Access Compliance Report

Public Rights-of-Way

Intersection ID: 26275	Main Street: PARK_RD	Cross Street: TRADEWINDS_LN	Location: NW
ADA ID: F24533EBDE3E	Ramp Type: PerpDiag	Initial Pass/Fail: Fail	Overall Compliance: No
Severity Score: 33.75			
Codes/Mitigation Info/Possible Solution		Field Measurements/Component Compliance

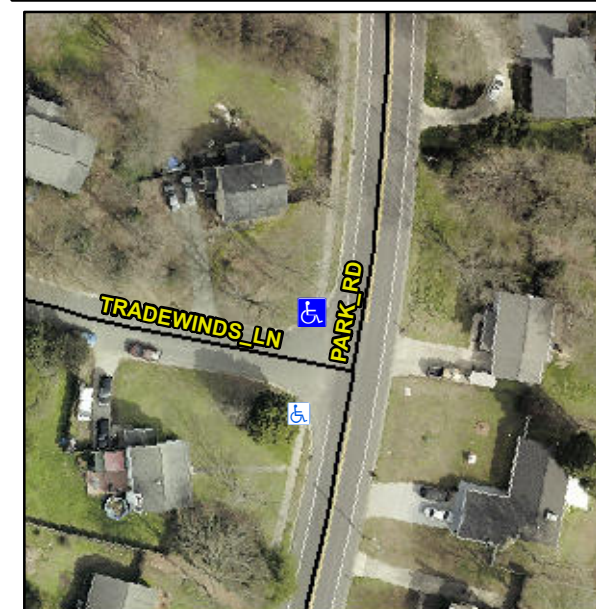
Not Found, R304.5.1, R304.5.3

Compliance	Description	Data	Compliance	Description	Data
N/A	Ramp Length (in)	68.0	Yes	Ramp Slope (%)	6.3
No	Ramp Width (in)	46.0	No	Ramp XSlope (%)	7.7
N/A	Flare Type LT	N/A	N/A	Flare Type RT	N/A
N/A	Flare Slope LT (%)	N/A	N/A	Flare Slope RT (%)	N/A
N/A	Flare Traversable LT?	N/A	N/A	Flare Traversable RT?	N/A
N/A	Landing Length (in)	N/A	N/A	DWS Provided?	N/A
N/A	Landing Width (in)	N/A	N/A	DWS Contrast?	N/A
N/A	Landing Slope (%)	N/A	N/A	DWS Length (in)	N/A
N/A	Landing X Slope (%)	N/A	N/A	DWS Full Width?	N/A
N/A	Landing Curb? (Y/N)	N/A	N/A	DWS Offset (in)	N/A
N/A	Shared Landing?	N/A			
N/A	Gutter Ponding?	N/A	N/A	Gutter Slope (%)	N/A
N/A	Gutter Lip Ht (in)	N/A	N/A	Gutter X Slope (%)	N/A
N/A	Painted X Walk1?	No	N/A	Painted X Walk2?	No
	X Walk 1 Direction	To S		X Walk 2 Direction	To E
N/A	X Walk 1 Width (in)	N/A	N/A	X Walk 2 Width (in)	N/A
	X Walk 1 Slope (%)	3.7		X Walk 2 Slope (%)	1.8
	X Walk 1 X Slope (%)	3.4		X Walk 2 X Slope (%)	2.8

Remove & Replace Curb Ramp With Two New Directional Ramps or Equivalent.
